5 December 2011

**ENVIRONMENTAL ASSESSMENT – DEXUS ESTATE INDUSTRIAL PARK PROJECT (MP 08_0259)
MODIFICATION (MOD 2) – SUPERLOT C AMENDMENT**

PJEP – Environmental Planning

Figure 3: DEXUS Estate Masterplan – As Proposed

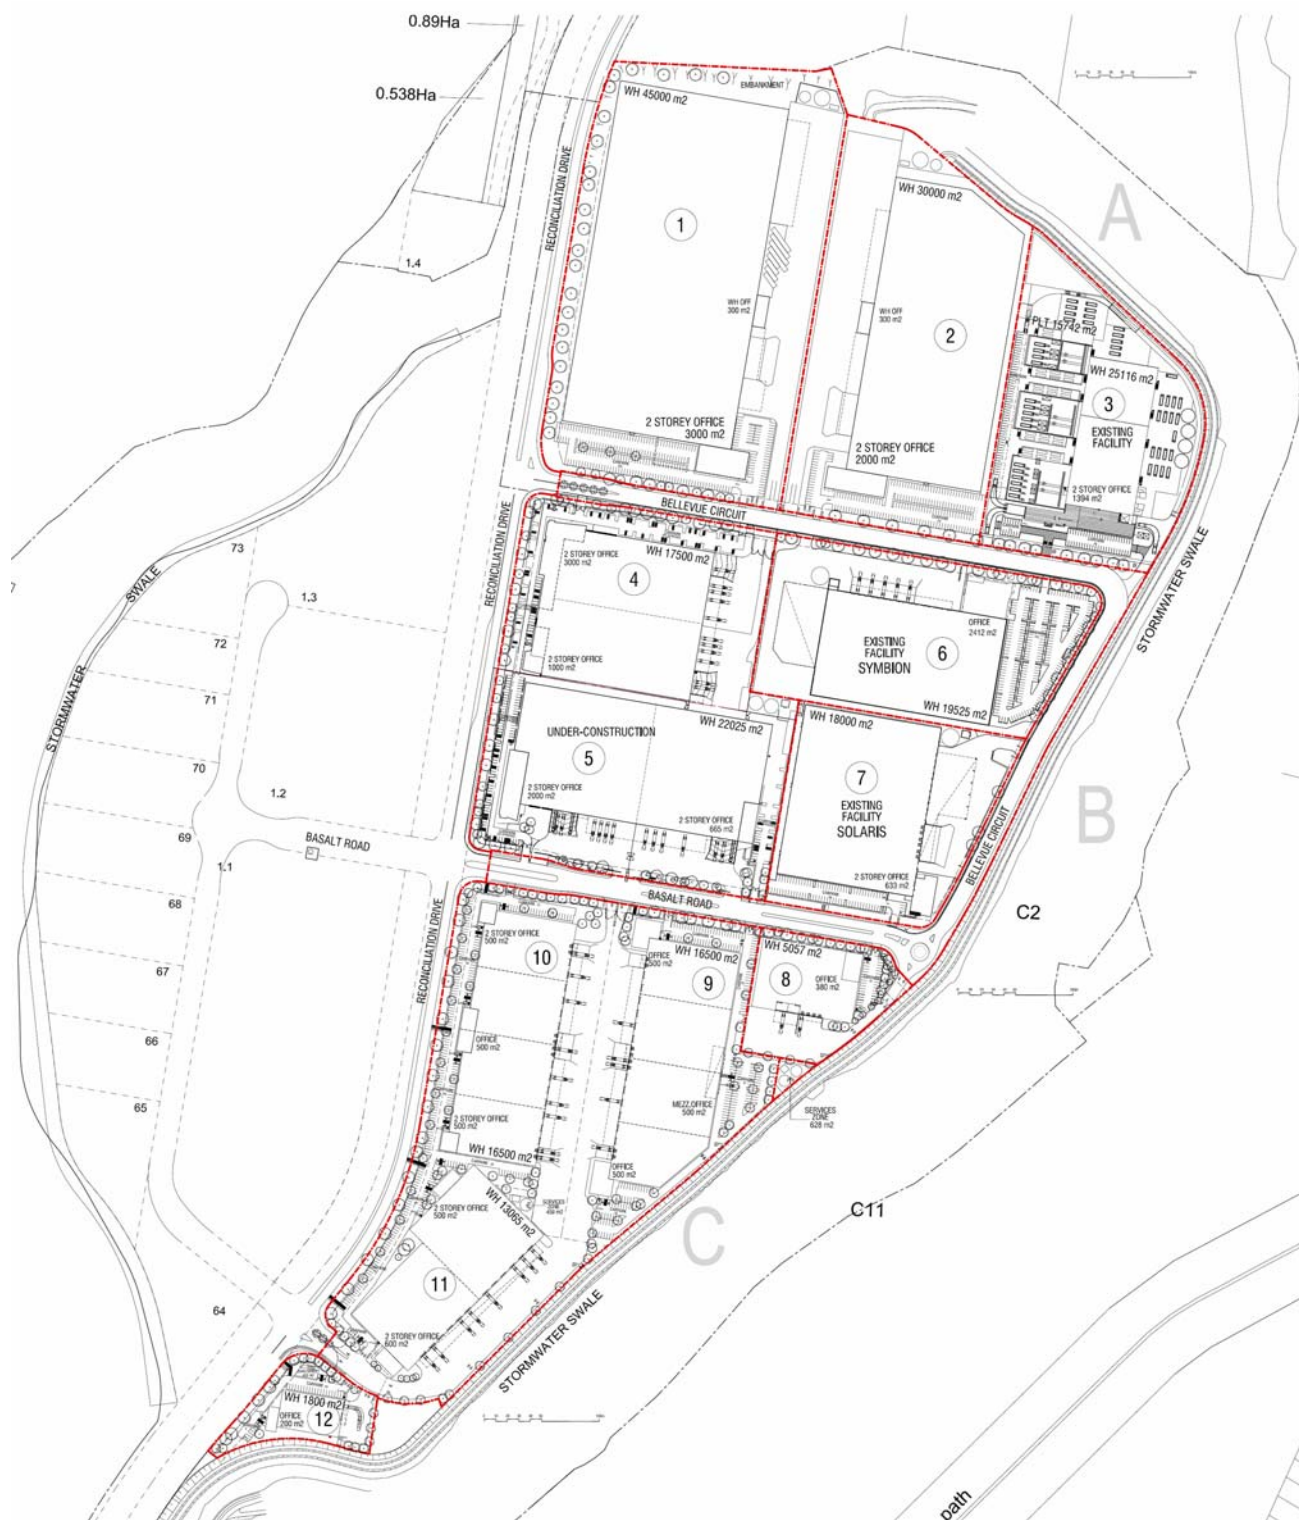
In accordance with this detailed review, DEXUS proposes to modify the project approval for the DEXUS Estate under Section 75W of the EP&A Act to revise the estate masterplan, including:

- amending the masterplan layout for Superlot C, including:
 - amending the subdivision and building layout for the superlot;
 - deleting the southern portion of Bellevue Circuit on the eastern side of the superlot;
 - adding an ancillary estate manager's office and café in the southern area of the superlot; and
- updating the masterplan layout for Superlots A and B to reflect the approved buildings on these superlots.

The proposed revised masterplan for the DEXUS Estate is shown on **Figure 3**. A full set of revised architectural design plans – based on the proposed masterplan – is attached as **Appendix A**. A revised Landscape Masterplan for the estate is attached as **Appendix B**.
